PERMIT

SEWAGE DISPOSAL SYSTEM

P 58945-A

SUBDIVISION Greenwood Farms LOT 6 ROAD 7530 Brown Bridge Road

P 58945-A

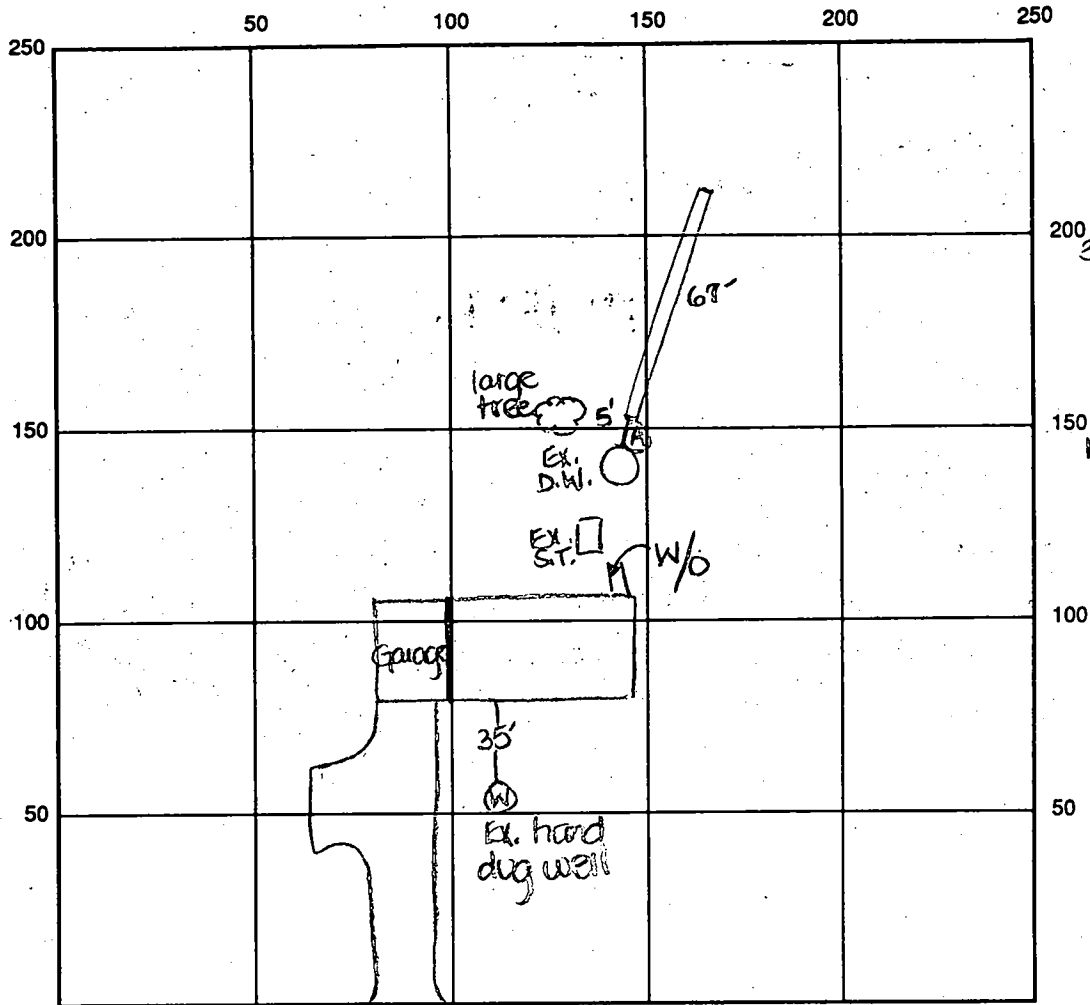
REPAIR - PURPOSE - SEPTIC SYSTEM HAS FAILED.

Call for inspection when ground is opened so sanitarian can recommend repair.
08/25/97

Install trench off existing drywell, on contour.
Trench to be 2' wide, inlet 4', bottom 10', stone 6'.

REMARKS: 8/28/97 A.M. OK to begin trench as specified. DKS
8/28/97 P.M. FINAL INSP - OK to cover all work as
completed. sufficient materials at site. DKS

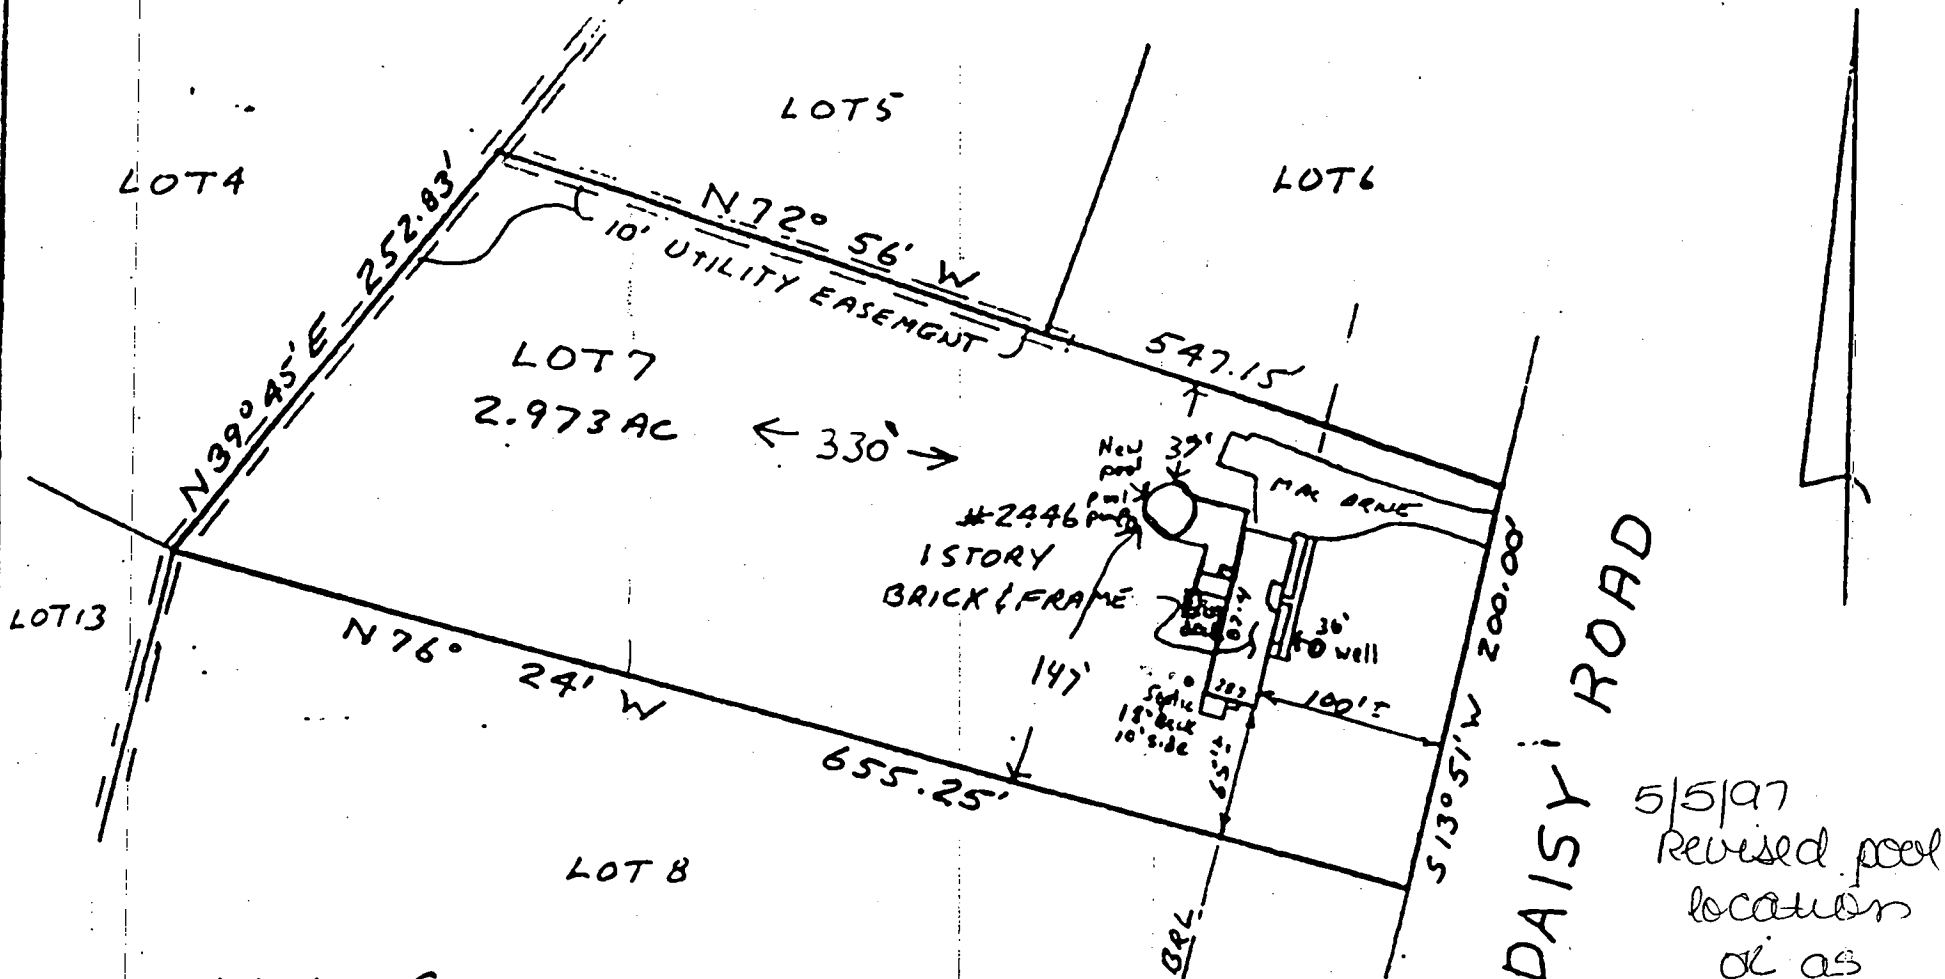
5/5/97
Revised pool location
Sincerely,
OK as shown.
Ray Walsh
301-854-6682 DKS

On Thursday, May 1, 1997, I came through your department. I anticipated obtaining a permit for an above-ground pool and a deck. I was advised, however, that pool (where it was located on the map) would be too close to the septic field setbacks.

The pool has since been re-located as indicated in the new drawing and is in compliance with the Health Department's requirements.
